## HISTORIC AND DESIGN REVIEW COMMISSION

**HDRC CASE NO:** 2022-538  
**ADDRESS:** 402 QUENTIN DR  
**LEGAL DESCRIPTION:** NCB 7059 BLK 8 LOT 10 E 35 OF 9  
**ZONING:** R-6, H  
**CITY COUNCIL DIST.:** 7  
**DISTRICT:** Monticello Park Historic District  
**APPLICANT:** David Montejano/MONTEJANO VERONICA GARCIA & DAVID  
**OWNER:** David Montejano/MONTEJANO VERONICA GARCIA & DAVID  
**TYPE OF WORK:** Rear patio enclosure  
**APPLICATION RECEIVED:** October 06, 2022  
**60-DAY REVIEW:** Not applicable due to City Council Emergency Orders  
**CASE MANAGER:** Claudia Espinosa

The applicant is requesting a Certificate of Appropriateness for approval to enclose the existing patio.

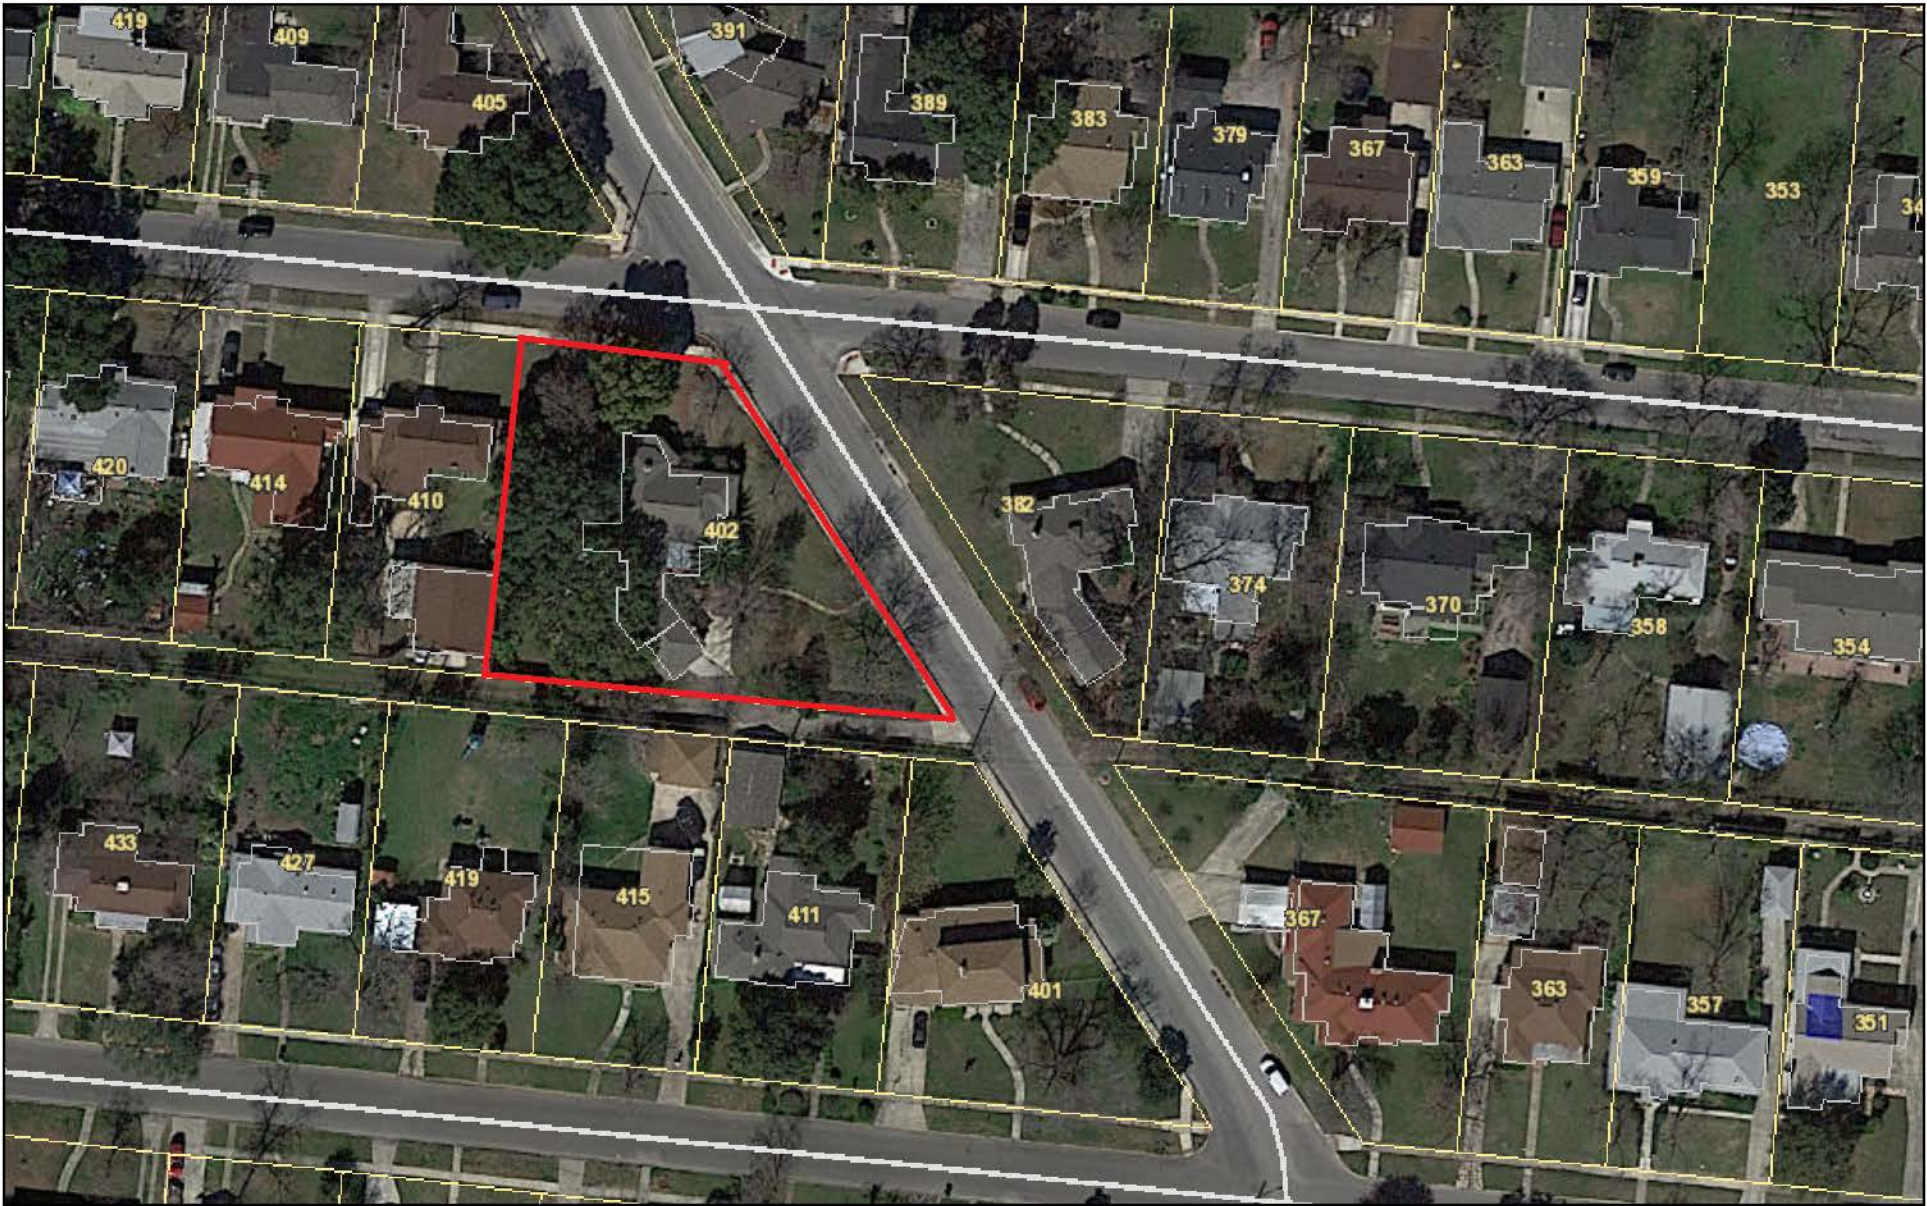
- a. The historic structure at 402 Quentin Dr. was constructed circa 1945, is first found on the 1951 Sanborn Map and is a contributing structure to the Monticello Park Historic District. The structure features both wood, one-over-one windows and steel casement windows, a rough-cut stone façade, and hipped roofs. At this time, the applicant is requesting a Certificate of Appropriateness for approval to enclose the existing rear patio.

- b. VIOLATION – The scope of work requested at this time was completed prior to the issuance of a Certificate of Appropriateness.
- c. PATIO COVER (Materials) – The applicant has proposed materials that include steel columns, corrugated metal on the lower and upper portions of the enclosure, screened window features, and a screened door with metal framing. The Guidelines for Additions 3.A.i. state to use materials that match in type, color, and texture and include an offset or reveal to distinguish the addition from the historic structure whenever possible. Any new materials introduced to the site as a result of an addition must be compatible with the architectural style and materials of the original structure. Staff finds the proposed materials to be inappropriate and inconsistent with the Guidelines. Staff finds that the applicant should use materials typically found in the neighborhood such as wood posts, wood framing, and standing seam metal or shingled roofing materials rather than the proposed materials.

Staff does not recommend approval based on the materials to be used. Staff recommends the applicant construct a patio with a wooden frame, posts, and appropriate roofing materials based on finding c. The enclosed patio should also be fully reversible and not damage the façade.
